Performance-Based Design Brief / Fire Engineering Brief Questionnaire (FEBQ)

Applicant reference number P00700

FRNSW reference number FRN23/3144

Premises name	Broadwater Public School
Primary street address	9 Byrnes Street

Figure 12: Undercroft area

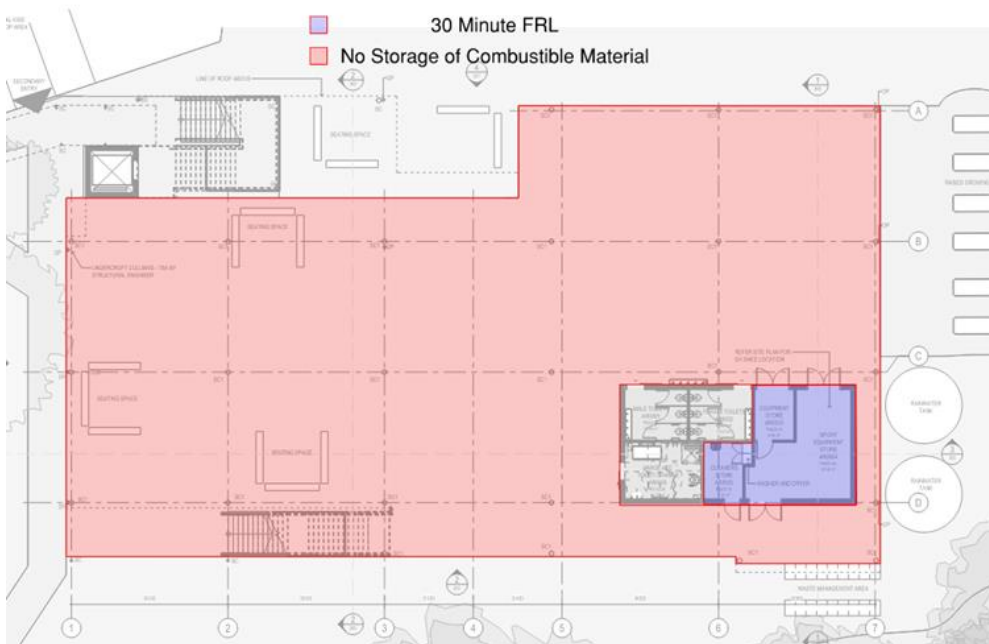
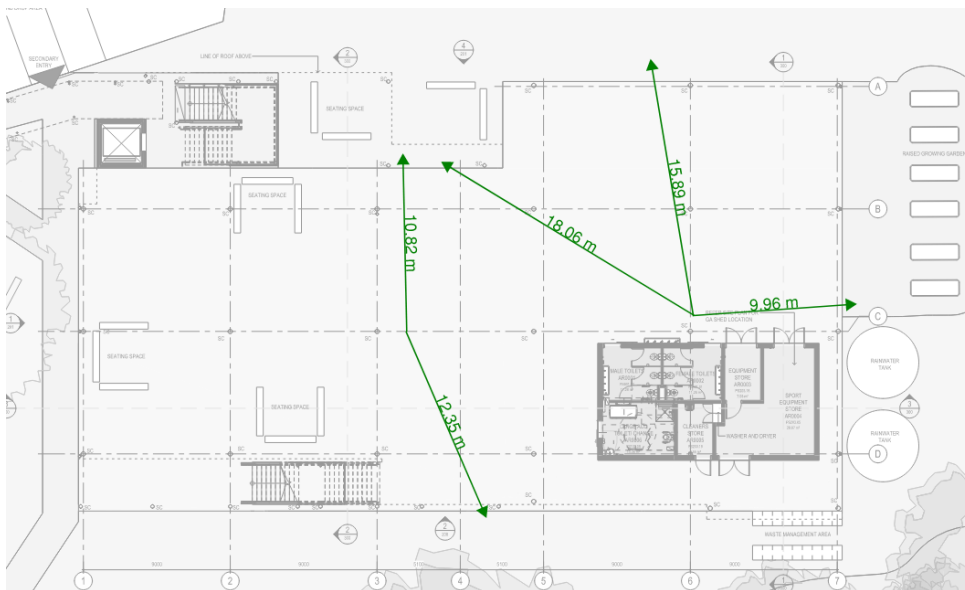
FRNSW Comment: FRNSW recommend management in use procedures be implemented to ensure the sterile requirements of the space are maintained accordingly.

E-LAB: Noted, see above.

Figure 29: Canteen walls to have PIR insulation.

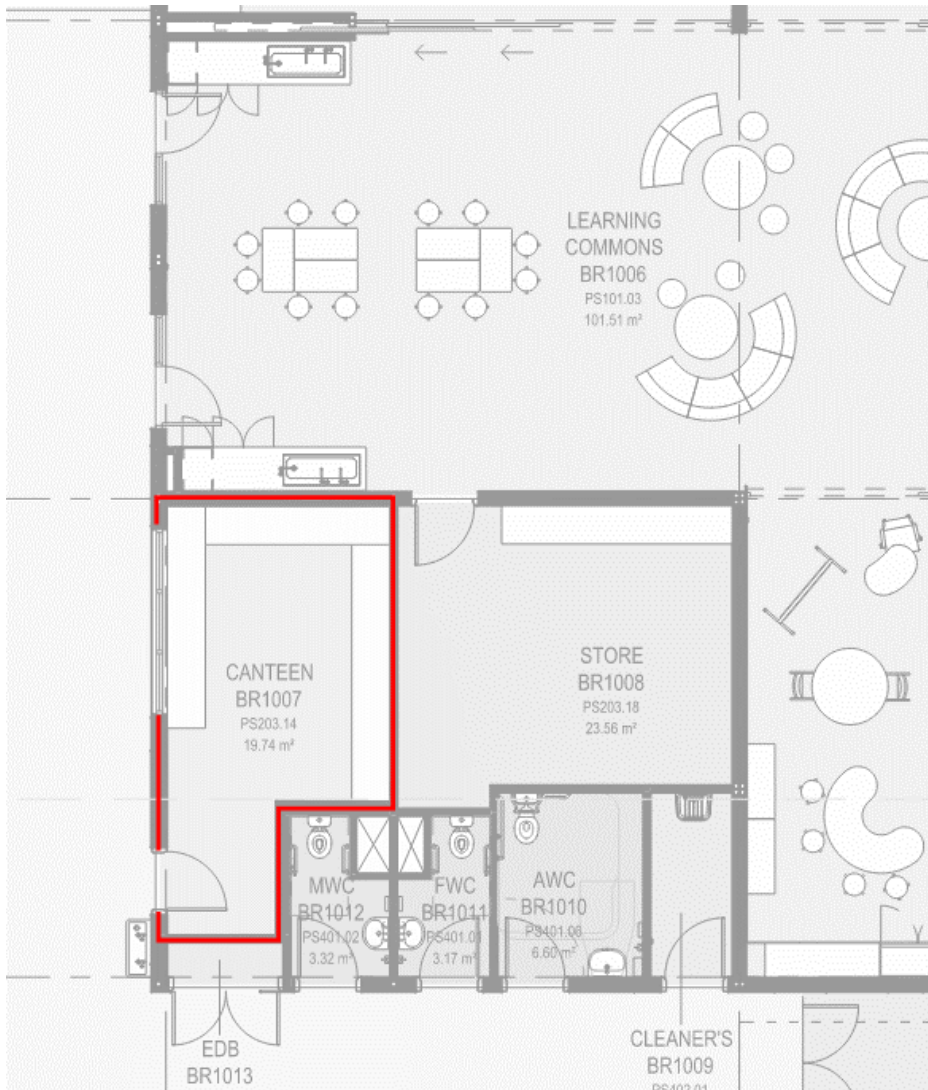
FRNSW comment: FRNSW recommend the extent of ISPs be clearly depicted to permit a considered review.

E-LAB: The PIR insulation is only to be installed in the walls of the canteen. All walls of the canteen shall possess the PIR insulation. The non-compliance strictly relates to the Type B construction requirements mandating all external wall to be constructed from non-combustible building elements. PIR while noted as being flame retardant does not meet the non-combustible requirements of the NCC.
